Fifth Report of the Vishwamitri Committee
(Constituted by the Hon'ble Gujarat State Human Rights Commission)

HRC/2024/PRESS/205/Vadodara City/legal-1

Report

Defunct OCEMS showing misleading results of COD, TSS, BOD, and pH

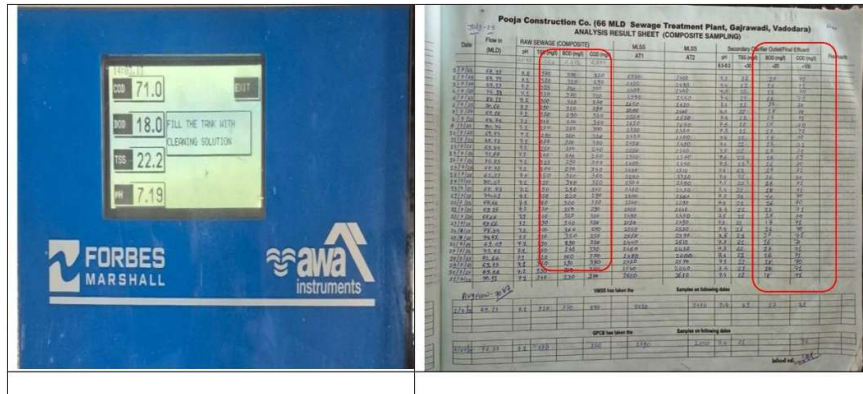
The following photographs show that OCEMS provided at final outlet of STP was not in operational conditions. However, the OCEMS showed values of COD, BOD, TSS and pH of 71 mg/L, 18 mg/L, 22.2 mg/L, and 7.19, respectively, which is misleading as there were no inlet and outlet pipes of treated effluent connected to OCEMS unit. When discussed with the laboratory staff, it was found that the lab staff were instructed to report values in close agreement with the above-mentioned fictitious values shown by OCEMS. The photograph showing the same is attached below. In the attached photographs it can be observed that the several BOD values of raw sewage are greater than corresponding COD values which is not possible practically, indicating the lack of technical competency of laboratory staff and absence of application of mind in recordkeeping.

BOD bottles partially filled with sample

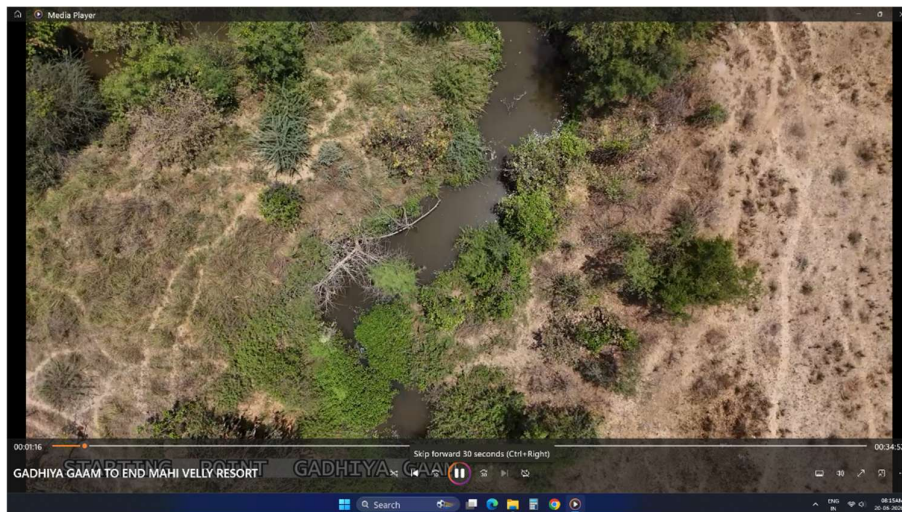
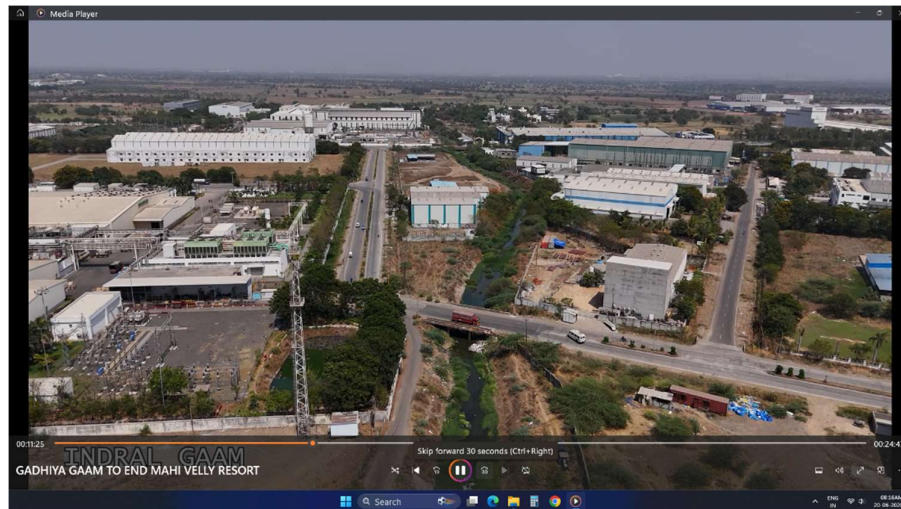
A Striking error was observed in the protocol used to measure BOD in several STPs (Chhani 50 MLD, Chhani-21 MLD, Vemali- 13 MLD, Rajivnagar-78 MLD, Bhayli- 45 MLD, Sayaji Garden-16 MLD, Kapurai- 45-MLD, Kapurai-60MLF). As shown in the photographs below, the BOD bottles of 330 ml volume were deliberately filled up to 300 ml volume leaving a 30 mL air space in the bottle. As per the Standard Method, the BOD bottles must be filled up to the brink and then stoppered so that there are no air voids in the bottles. Any air space left in bottle (as per the protocol followed by STPs) will supply oxygen during the incubation process and the BOD results obtained by such method will always be significantly lower than the actual BOD values. The oxygen contained in ~30 mL air at 20 C will be about 7 mg. If the sample (treated or raw sewage) placed in the BOD bottle is diluted 10 times, it will show negligible BOD even if the actual BOD is ~ 70 mg/L.
